# RotorSport UK Ltd

## Service Information Letter

**SIL-013**

## Subject: 2-year replacement of low-fuel-level sensor

Tank removed from LHS of aircraft

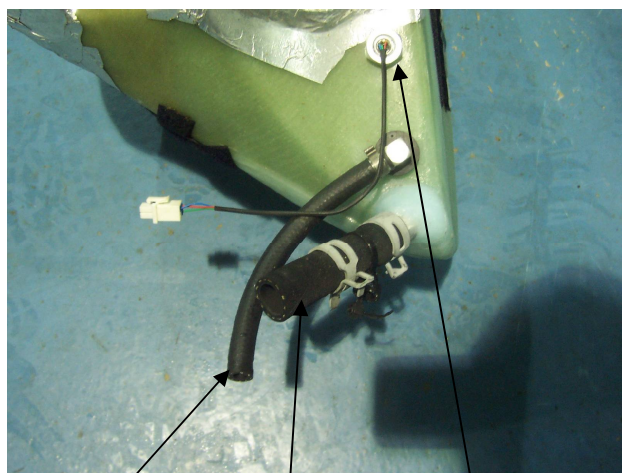
To access the fuel sensor in Calidus aircraft it is necessary to drain all fuel and remove the left-hand fuel tank (see AMM RSUK0061). Only Optomax sensors will be found in Calidus aircraft.

The low-fuel sensor RSD4555 or RSD4335 should be replaced every two years (alternatively function checked every six months). Replacement sensors are supplied with metal housing, O-ring and back-nut as Installation kit RSD7195.
